Office Action Summary	Application No. 10/658,308	Applicant(s) RENZ, CHARLES J.	
	Examiner Kevin T. Truong	Art Unit 3734

DETAILED ACTION

Note: This is in response to the Amendment filed 06/22/2009.

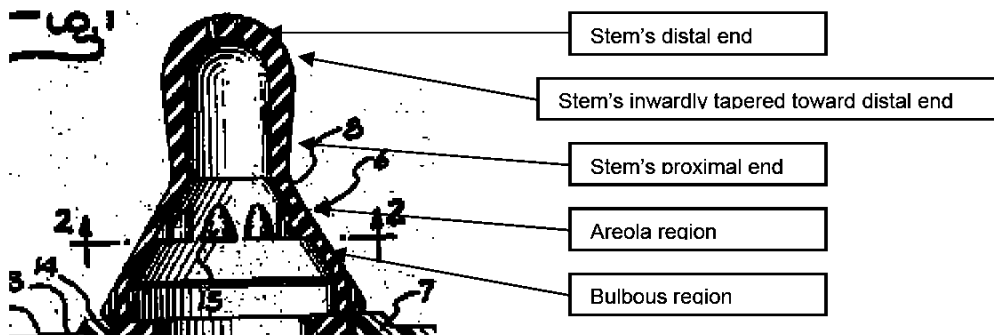
2. Claim 34 is rejected under 35 U.S.C. 102(b) as being anticipated by Witz (US 2960088).

Note in figure 1 of Witz, a stem (as shown in fig. below) having orifice (19), proximal and distal ends (as shown in fig. below); an areola region connected to the proximal end of said stem; and a bulbous region being connected to said areola region, wherein said areola region is substantially concentrically aligned with said bulbous region when viewed in a top view and wherein said proximal end of said stem has opposing sides with inwardly concave shapes when view in a front view; and wherein said areola region and said proximal end of said stem are connected along an inwardly concave surface and wherein said inwardly concave surface is smooth.

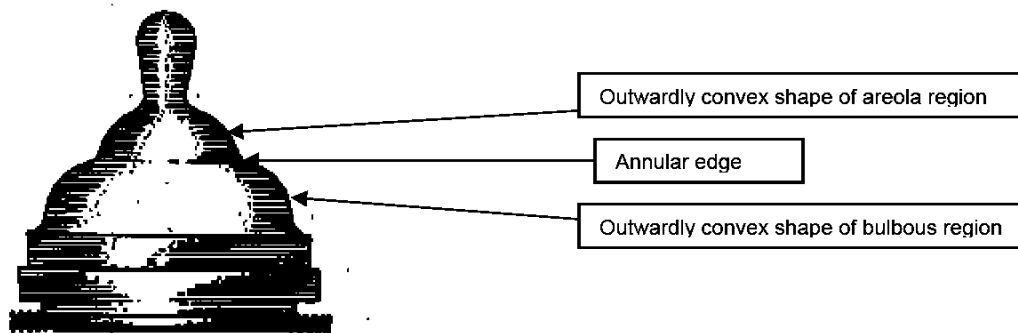
4. Claims 37-40 and 43 are rejected under 35 U.S.C. 103(a) as being unpatentable over Witz (US 2960088) in view of Porthouse et al. (Des. 130,791).

Witz discloses the claimed invention (as state above) except for the outwardly convex shape of the bulbous and areola regions and the annular edge disposed thereof.

Porthouse et al appears to teach that it is known in the art to have the outwardly convex shape of the bulbous and areola regions and the annular edge disposed thereof (as shown in fig. below).

For this reason, it would have been obvious to one of ordinary skill in the art at the time the invention was made to modify nipple of Witz by having the outwardly convex shape of the bulbous and areola regions and the annular edge disposed between the areola and bulbous regions as taught by Porhouse et al in order to enhances the comfort of baby's mouth while sucking on the nipple.
